Airworthiness Directive Schedule

MD Helicopters 369 Series, 500N and Kawasaki-Hughes 369 Series

28 November 2024

Figure 1 - Inspection Location

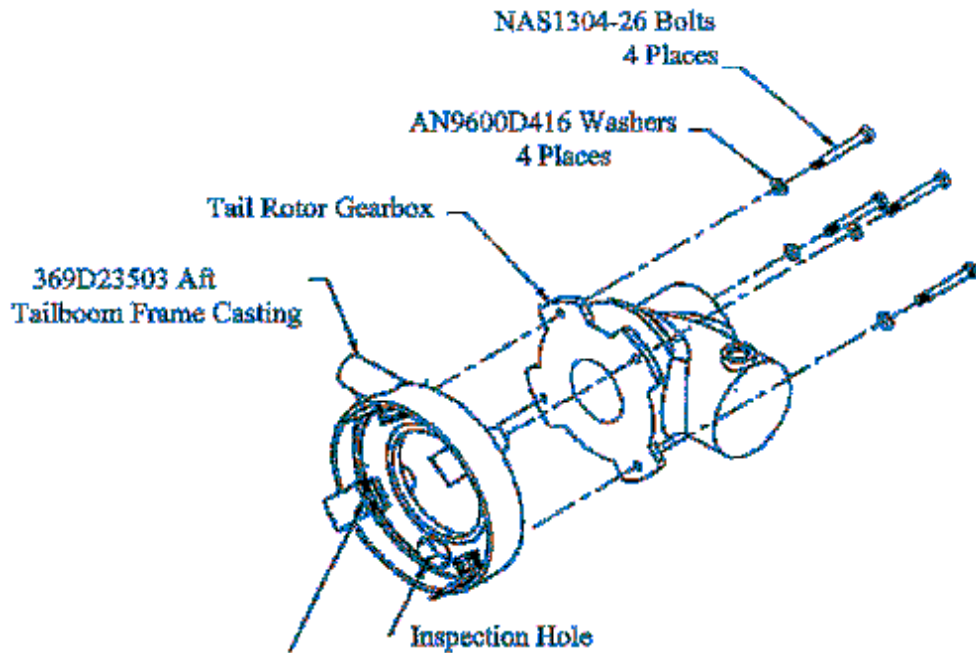
1. Determine the P/N of each tail rotor gearbox attaching bolt. If the P/N cannot be determined or if the bolt is not P/N NAS1304-26, replace with bolt, P/N NAS1304-26, before further flight. Torque the bolt to 100-110 in-lbs and apply a slippage mark.
2. Remove the tailboom control rod and determine the number of bolt threads protruding from each nutplate on the internal surface of the aft tailboom frame casting, P/N 369D23503, as shown in Figure 1 of this AD. At least one thread must protrude. If more than four threads protrude, add an additional washer, P/N AN960D416, under the bolt head. Torque the bolt to 100-110 in-lbs, and reapply a slippage mark.
